**CITY OF ALBANY  
OYSTER HARBOUR FORESHORE  
MANAGEMENT PLAN  
ENGAGEMENT OUTCOMES REPORT**

**SHAPE URBAN**

The City are now seeking more detailed plans and guidance for the management of Oyster Harbour, through the preparation of a Foreshore Management Plan (FMP) comprising General Management actions and a Landscape Master Plan.

FIGURE 5: CONCEPT PLAN - PARKLAND | FORESHORE

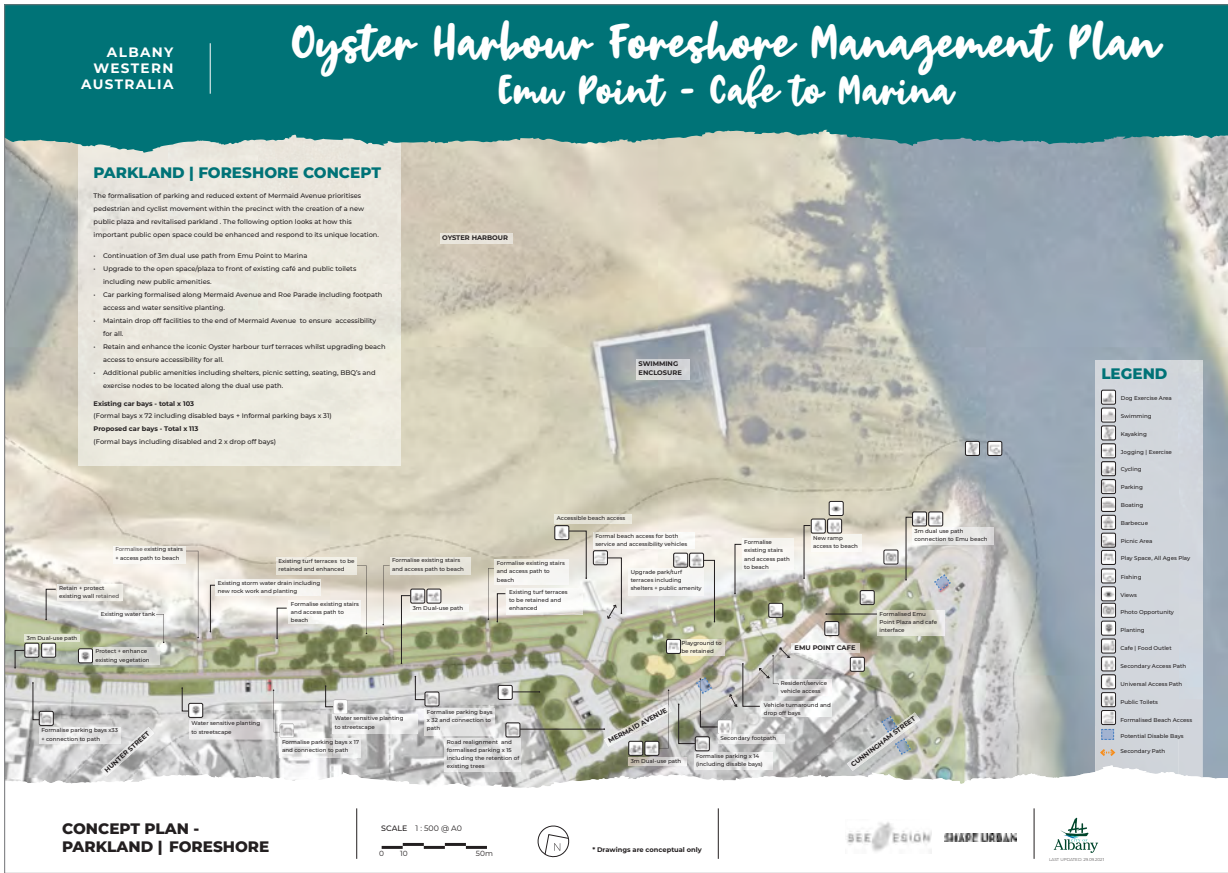
A summary of the key comments raised regarding the parkland/foreshore concept plan are outlined below.

- Parking - easier, more parking along Roe Parade, remove from in front of playground, more at the playground (where bins are)
- Paths - Walk/bike path from Roe Parade to boat ramp, dual use path from cafe to Swarbrick Street, extension of dual use path, terminate at southern end of cafe
- Food options for busy holiday times
- Enhancement of terrace

- Level of parking on Roe Parade to allow views
- Public toilets too far from zones 2 and 3
- Dual use paths - paths through parkland
- Parking - handicapped should be closer to cafe
- Clarifications - route of cycle/path in front cafe, use of plaza
- Need to increase the separation between the parking area and the playground

- Fencing to separate playground and road
- Boardwalk across river
- Parking - for people with disabilities close to amenities and cafe, create more west of BBQs
- Access - disability access to terraces in zone 2 and 3
- Public toilets in zone 2 and 3
- Traffic - Divert all Mermaid Ave traffic around Roe Parade
- Suggest moving the path in the north western end of the foreshore to run behind the toilet block rather than through the park

However, a few elements were notable for causing some concern, being the dual use path proposal, due to concerns about speeding cyclists, and parking along Roe Parade in particular, due to concerns about loss of views. Some concerns were also raised regarding parking in Cunningham street on the southern side of Emu Point due to concerns about congestion.

Alternatives to the dual use path were recommended, including using the existing road network for cycling and making Roe Parade a one way loop. It is noted that separating private vehicles and cyclists/pedestrians was a specific objective of this FMP, and a proposal to encourage cycling on road for recreational users conflicts with this intent.

No significant alternative to parking in either Roe Parade or Cunningham Street were suggested, although, an improved layout of the Roe Parade and Mermaid avenue intersection was suggested, which may result in more parking in this location.

Comments also recommended removing parking adjacent to the west side of the playground entirely, removing any reason to enter Mermaid Avenue beyond the intersection with Roe Parade unless doing a pick-up or drop-off.

It is recommended to reconsider the Mermaid Avenue and Roe Parade intersection vis-a-vis parking limits further along Mermaid Avenue. This would limit the need to fence the playground, although some barriers could still be provided to enhance safety along the drive through loop.

Further consideration is also recommended to be given to the informal parking area that is formalised in the concept. Suggestions to locate the Roe Parade alignment further to the west should be assessed.

With regard to the dual use path, it is recommended that the City progress the design in the current concept location (or similar). The decision to include the dual use path is from broader strategic planning and is a specific recommendation of other documents. Consideration should be given to signposting speed limits through the parkland, although it is expected that any commuter or distance cyclists will stay on road as a preference.

FIGURE 6: MARINA OPTIONS

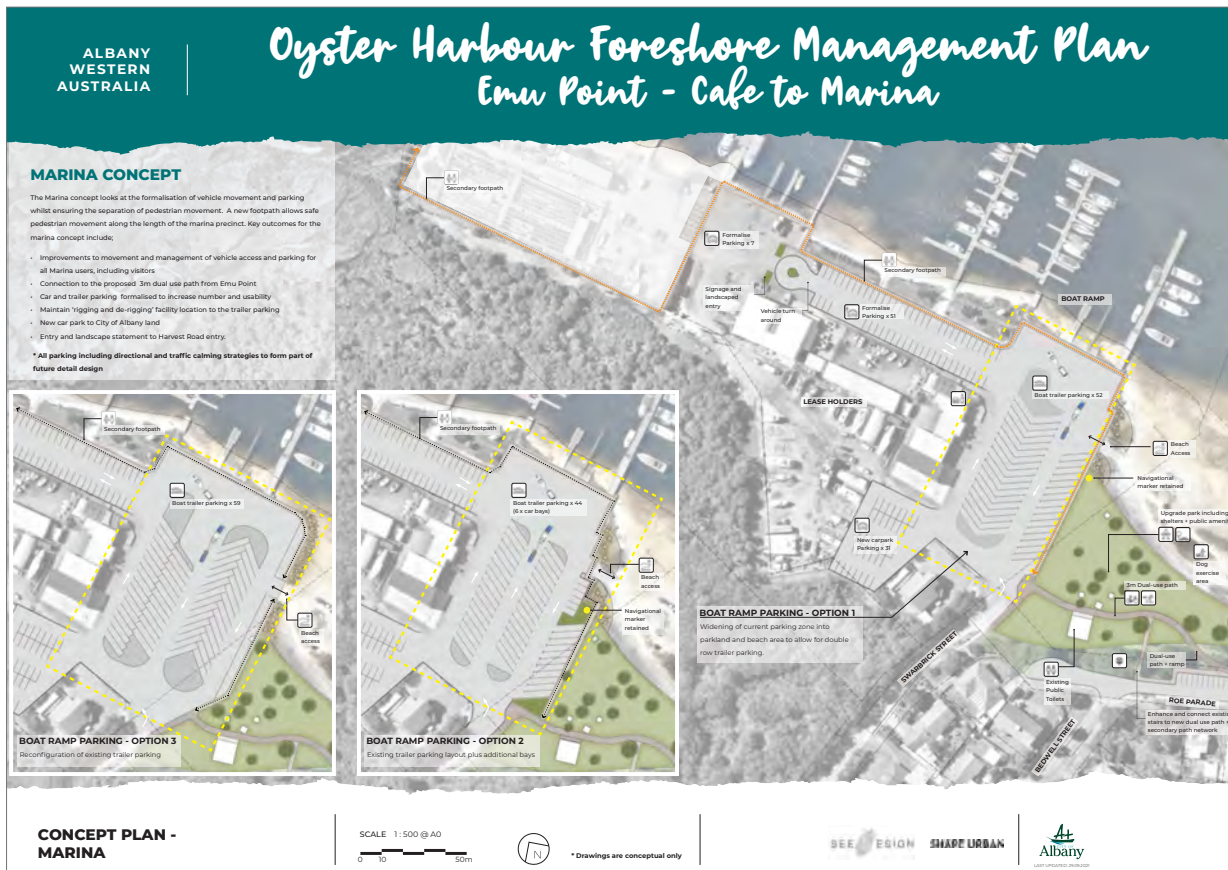
#### **Boat trailer parking Option 1**

- Concerns regarding the need to back boat trailers in or out of parking bays.

#### **Boat trailer parking Option 2**

- (Essentially the current arrangement) works well
- Concerns relating to reversing boat trailers
- Change angle of parking in the south side

#### **Boat trailer parking Option 3**

- Has the greatest parking capacity
- Concerns regarding congestion, boat trailer parking
- Suggest changing direction of boat trailers near sea rescue

Option 2 for boat trailer parking was clearly the preferred option from all stakeholders, reflecting an almost identical existing condition. Some improvements were suggested to direction of bays.

The feedback on this Zone was strongly in favour of Option 2, which retains the current arrangement and a small addition to the parkland edge (south). Notwithstanding, it was suggested that the direction of the herringbone style along the parkland edge be changed.

It is recommended that the direction of the herringbone pattern on the park edge be assessed and amended if suitable.

A number of submissions and stakeholders made clear that the area in front of the Sea Rescue building needs to remain clear. Option 2 retains the current layout.

Parking along the marina water edge was also strongly supported. The cul-de-sac turning head was queried as it impacts business access and trafficability. It is recommended that this traffic feature be reconsidered to avoid impacting business access.

It is recommended that more detailed design be undertaken for this parking area to ensure proposed layouts do not impact businesses and access to services.

**\* SUBMISSION ATTACHMENT -  
CONCEPT 3 MARK UP**

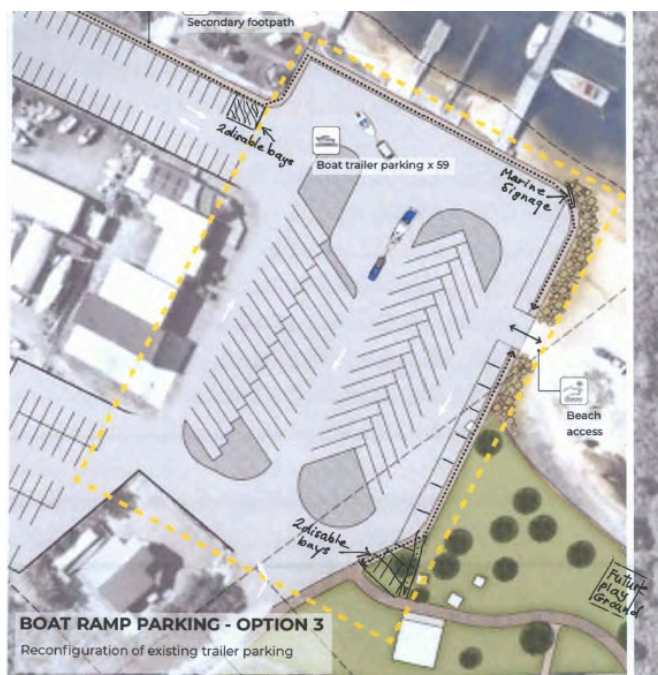
3. Tell us what you like about Boat Ramp Parking Option 3
Had the most parking bays
The general layout of boat ramp parking doesn't need changing but boat trailers should be able to go anti clockwise near the sea rescue
Has best parking capacity.
Total impracticable [sic] and unworkable. Will cause congestion, frustration and crowding. Too many bays for what ramps can handle. It's a restricted area - unlike town jetty.
Again try parking boat trailer.
This is even worse than option 1.
Dont agree

4. Is there any element of either options that you think is essential?
DOG AREA near toilets (-boat area) needs at least (2) shelters. - The new ones being built offer little shelter - Needs some sides from SMW wind (not so tall)
Continuous bike path's The parking defined next to the squid shack
So they can drive thru from near there. Perhaps 2 way arrows for that section. For the few times a year the eastern foreshore as it is, is a good option for excess boat trailers. Like extra parking behind sea rescue
A disable parking bay by 3m. Dual path form Swarbrick St for access to public toilets
<ul style="list-style-type: none"> <li>Disability parking needed - 2 x at fish cleaning site opposite existing restaurant. 2 x entrance to dual path from zone 4 for easier access to toilets and facilities Both 5-10m from parking (My key request - see attached*)</li> <li>Make 7-8 standard car bays adjacent to footpath on zone 4 boundary.</li> <li>Place marine signage at the corner of boat ramp parking so it is clearly visible to boating community.</li> </ul>

Option 2 works well as is. Need pack up area for getting ready to launch and pack up area for after retrieval.
Easier access, and herring bone design for boat parking area. New parking area near fishing club should have a road behind with access to Swarbrick St.
Only option 2 works. Do not support removing part of dog and people exercise area. Creating car park overflow is a good idea in the current bush area.
Parking next to fishing clubs.

CONCEPT MARK UP BY COMMUNITY MEMBER

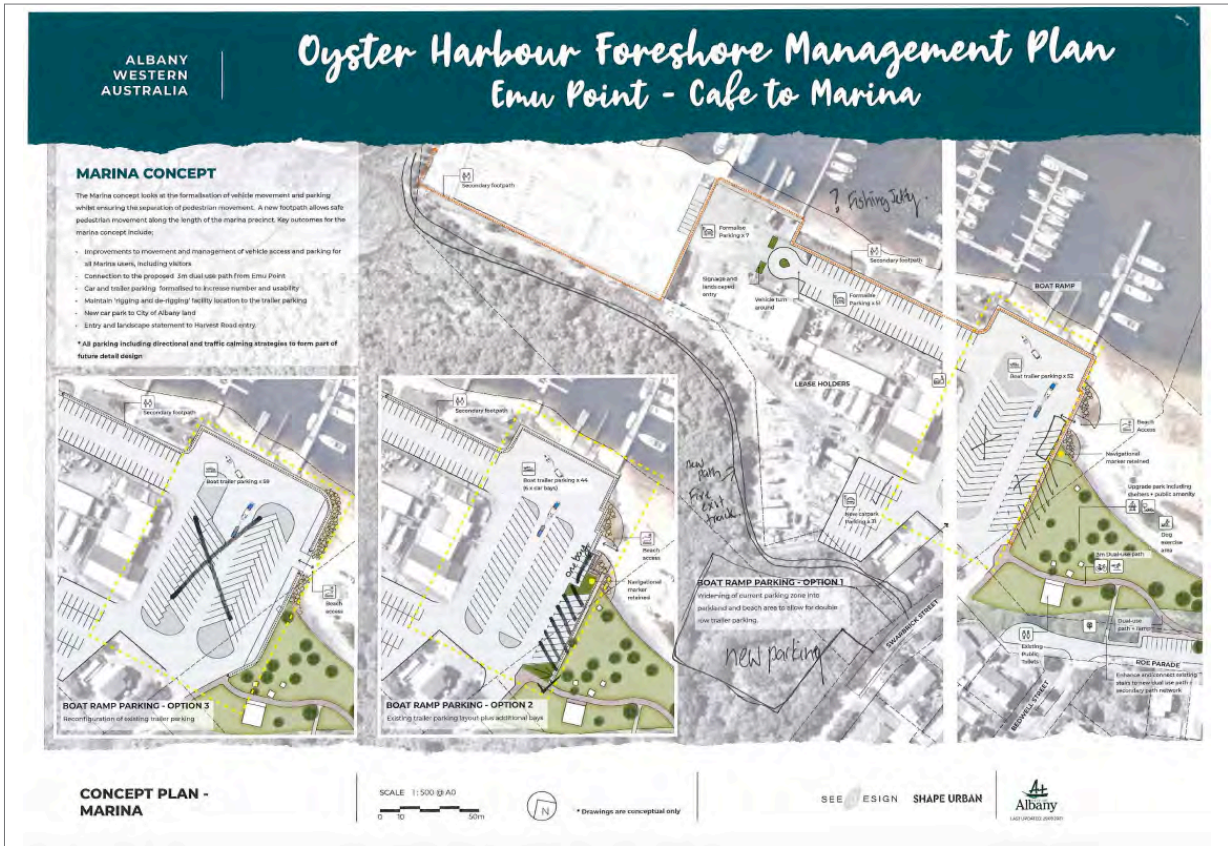
9. Do you have any other suggestions for the project area or any additional comments on this project?
Will people with disability have easy access to cafe, and beach area.
The removal of the disabled parking from next to the cafe to a place further away is not good. Needs to be disabled parking closer to cafe.
The key omission is catering for seasonal tourists in the Caravan Parks with amenities in Emu Point. This important feature has not been integrated.
The disability accommodation on Hunter St should have access to the beach on ramp [illegible] towards cafe end of beach immediately at Roe/Hunter.
A small jetty/pontoon for boats and fishing at end of the point would be welcome.
Run path from Roe Parade behind the toilets
Disability access and boat mooring ability here (Emu Point)
Concern about dual use path here (through the park near Emu Point)
Commuter cyclist pathway along Burgess St and run bike path along the western edge of new car park area - suggest be connected to existing path along Cunningham St on east side of Burgess St and upgrade bus stop to concrete slab

Create more parking here (near Roe Pde Mermaid Ave intersection) and pathway to cafe - push as much parking back from cafe turnaround - vehicle turn around and drop off ok, but less parking
Bring road along western edge at Roe Pde - possibility to look at one way along Roe - keep as many people out of the point as possible - service vehicles, private access and disabled parking/small transport buses only
Alternative move car park east and pathway to west side of car and join pathway on Mermaid Ave and add a calming device on road way at intersection of Mermaide and Hunter St to slow traffic entering parking area on Mermaide Ave - also stops caravans and trailer entering this area
Disability support houses located south side of Hunter St - connect path from here direct through the grassed zone - path headed east from here to the access beach preferable - design team will review required grades to provide feedback on how much impact this may have on terraces

9. Do you have any other suggestions for the project area or any additional comments on this project?
Continuation of path along Swarbrick linking with existing bike path through the reserve to Bayonet Head - can we reduce the path to 2m wide beyond this point.
Turnaround doesn't work in front of businesses
Reconsider the road through the back of Harvest Road, or square off the reserve and improve general layout
Disability fishing is being squeezed - needs and alternative here for both parking and access - Emu point could be a good alternative - but weather/wind less amenable - has some benefits - boats to national park, access to cafe etc
Traffic and parking plan for the marina - where will staff will be parking - want to make sure HR pays for traffic impacts
